Our Ref: AEH/1251.01/L0001
Your Ref: PA/20/02488/A1
26 March 2021

Phased Hybrid Planning Application, Orchard Wharf, Orchard Place, London
Application Ref: PA/20/02488/A1

- 1.1 Air Pollution Services (APS) were commissioned by Orchard Wharf Campaign Group (via London City Island Residents Association) to carry out a critical review of the air quality assessment of the Proposed Development at Orchard Wharf in the London Borough of Tower Hamlets (LBTH). An Environmental Statement (ES), dated November 2020 (Ramboll, 2020), accompanied the Applicant's planning application. Chapter 12 and its Technical Appendices covers air quality.

Figure 1: Study Area Receptors

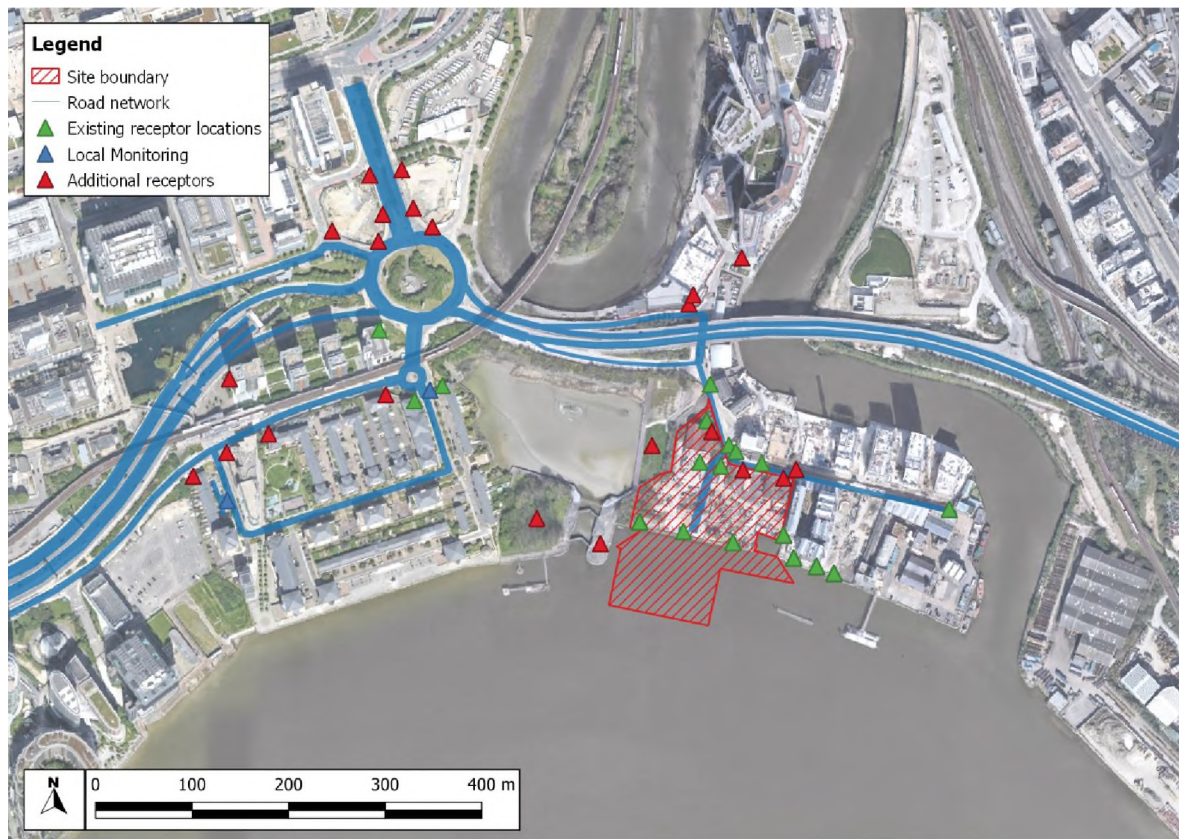
- 4.4 Figure 1 shows example receptors (red triangles) where there are significant emission sources in the study area and where the receptor could be sensitive to small changes in emissions. Note, it is not limited to these example locations. The receptor locations which have been missed represent, for example:

- locations where members of the public could reasonably be expected to spend one hour or more;
 - new developments which are currently under construction (e.g. east of link 7, Figure 2, page 14, where there are 750 additional vehicles from the Proposed Development in isolation);

- locations near to high emission sources where even small changes could have an impact (e.g., busy roads); and
 - locations where the development could result in a change in streetscape characteristics and result in a build-up of pollutants at ground level (i.e. there is potential for street canyon effects).

Figure 2: Modelled Road Links and Speeds

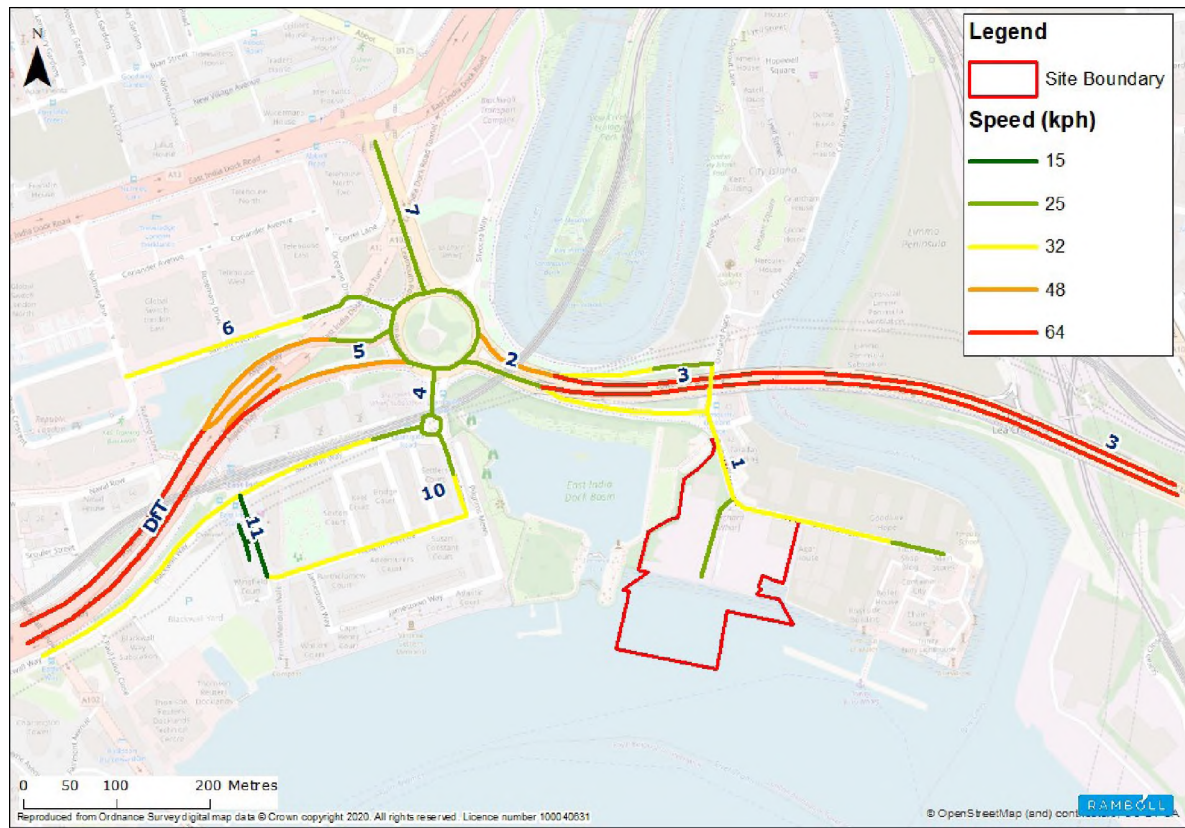
- link 10 (Newport Avenue) reduce from 969 in 2019 to 374 in 2027 (61% reduction).
- 4.10 No explanation is given for the reduction in traffic for these road links. It is important because these large reductions in the baseline flow will significantly change the predicted air quality in the future assessment year and the impacts of the Proposed Development.

- 4.15 A major concern is the limited road network included in the model. The traffic data suggests that 750 development related vehicles will travel along link 7. The whole of Tower Hamlets is an Air Quality Management Area (AQMA). According to the EPUK/IAQM guidance, which the Applicants has used for the assessment, the air quality impacts should be assessed where there is a change in traffic of greater than 100 AADT for LDVs or 25 AADT for HDVs. The assessment states all links have been included which meet these criteria (ES Chapter 12 paragraph 12.24). However, these 750 vehicles will continue along the road network, possibly to highly sensitive locations, that have not been considered in the assessment. Therefore, the air quality assessment is incomplete.

- 4.18 The average traffic speeds used on the air quality model are shown in Figure 2. The traffic speeds reduce at major junctions where there may be congestion. However, the average speed for link 1, for example, has been set to 32 kph (20 mph) and the speed limit is 20 mph. Given the number of vehicles turning in and out of the Proposed Development, it is extremely unlikely that the average speed will be the maximum permitted speed on the local road. The modelling would benefit from more granular data on traffic speeds and vehicle movements. As a minimum, it should use an
